**Re: IWWC #A20-7.1 / 5 & 21 Toelles Road & Wharton Brook
Pfizer Inc. Soil Remediation Project**

On behalf of Pfizer Inc. (Pfizer), Woodard & Curran (W&C) is providing this letter in response to the Milone & MacBroom, Inc. (MMI) letter dated December 22, 2020 regarding the subject Inland Wetlands and Watercourses Commission (IWWC) permit application. MMI's December 22, 2020 letter was provided as a response to W&C's letter dated December 4, 2020. The December 4, 2020 letter provided responses to 13 comments provided in MMI's letter dated November 13, 2020. In MMI's December 22, 2020 letter, seven of the prior comments (C2, C5, C7, C8, C9, C10, and C13) were indicated to have been addressed by the December 4, 2020 responses, and no further discussion of these comments is required. Per the December 22, 2020 letter, six of the comments require additional responses and two new comments require responses. The six outstanding and two new comments are provided below in **bold** and the responses (both December 4 and December 29) follow each comment. A summary of the laboratory results and the laboratory reports from the supplemental soil sampling performed on November 24, 2020 are provid

TREE PROTECTION

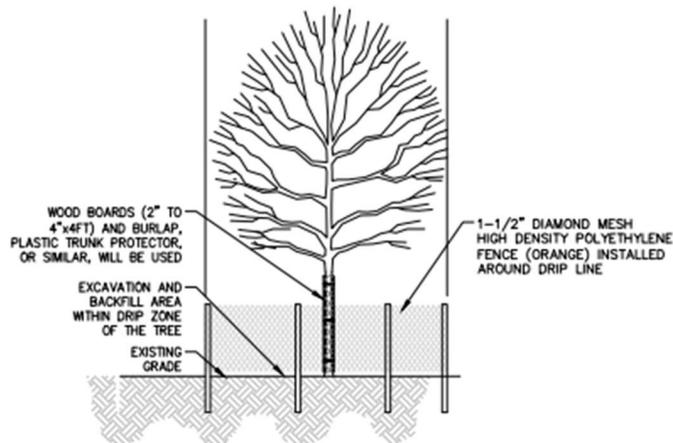
C6. November 13, 2020 comment

The applicant should provide tree protection details for those 15-inch DBH trees that will remain within the wetland remediation area. Damage to tree trunks and roots must be minimized to the maximum extent practicable.

December 22, 2020 comment

Comment addressed, and Tree Protection Notes have been reviewed. We recommend adding this final measure to Note 2: "Weekly site inspections during the course of excavation shall be performed to ensure damage to remaining trees is minimal and has been satisfactorily addressed in a timely manner by the contractor."

December 4, 2020 response. Prior to beginning site construction, the Contractor will be required to submit a tree protection plan for review. The following tree protection notes have been added to Sheet G-001.

The following tree protection detail has been added to Sheet C-202.

The following note has been added to the Tree Protection Notes on Sheet G-001.

Weekly site inspections during the course of excavation shall be performed to ensure damage to remaining trees is minimal and has been satisfactorily addressed in a timely manner by the contractor.
